UNITED STATES PATENT AND TRADEMARK OFFICE

APPLICATION NO.	FILING DATE	FIRST NAMED INVENTOR	ATTORNEY DOCKET NO.	CONFIRMATION NO.
10/614,956	07/08/2003	Victor Suen	02-6052	7138
24319	7590	07/27/2006	EXAMINER	
LSI LOGIC CORPORATION 1621 BARBER LANE MS: D-106 MILPITAS, CA 95035			CRAWFORD, JASON	
			ART UNIT	PAPER NUMBER
			2819

Office Action Summary	Application No. 10/614,956	Applicant(s) SUEN ET AL.	
	Examiner Jason Crawford	Art Unit 2819

DETAILED ACTION

Reference Fig A (Claims 9, 12)

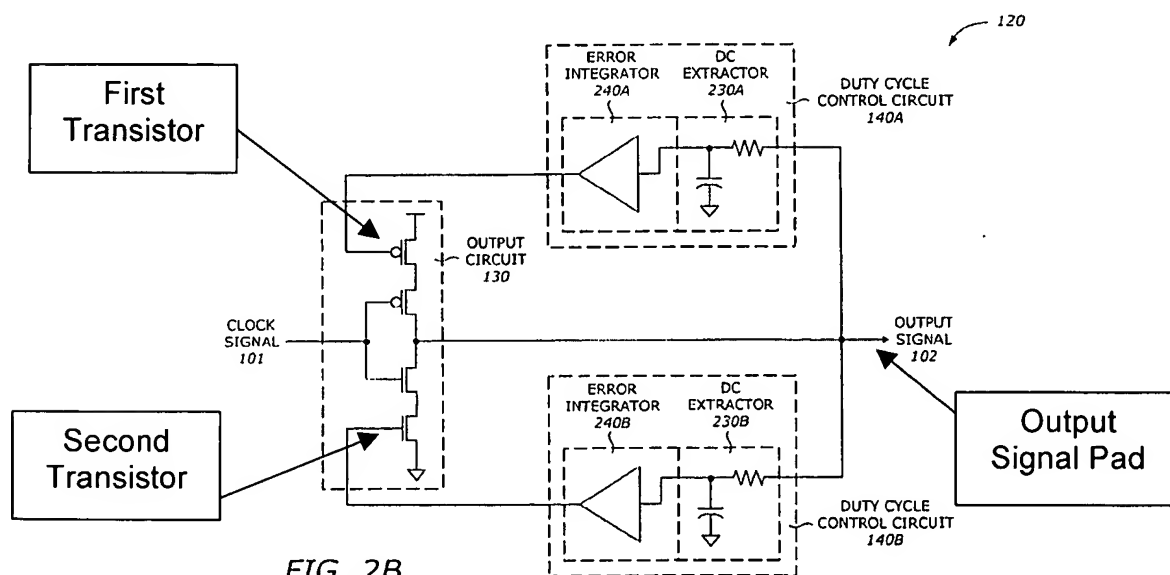
In regards to Claim 9, Nair discloses of an I/O device (120 in Fig 2B) comprising an output signal pad (pad at which 102 is output, see **Reference Fig A** below) configured for transferring a data signal (102) to another device coupled thereto, an output driver (130) comprising a first transistor and a second transistor (See **Reference Fig A**) for providing the data signal (102) to the output signal pad, and a duty cycle controller (140A, 140B) comprising a first logic circuit (240A) coupled to a gate of the first transistor and a second logic circuit (240B) coupled to a gate of the second transistor wherein the duty cycle controller (140A, 140B) is configured for balancing the duty cycle of the data signal with respect to a clock signal (101, the changed duty cycles of the first and second transistor will be output based on the value of the clock signal, which is gated to the other transistors). (Fig 2B, Paragraphs 0022-0024)

In regards to Claim 10, Nair discloses of the first logic device (240A) and the second logic circuit (240B) are adapted for gating the data signal (102) to the output driver (130) using the clock signal (101). (Fig 2B, Paragraphs 0022-0024)

In regards to Claim 12, Nair discloses of a controller (110 of Fig 1) for determining when the data signal (102) is to be transferred to the signal pad (see **Reference Fig A**). (Fig 1, 2A, Paragraphs 0014-0017 and 0022-0024)
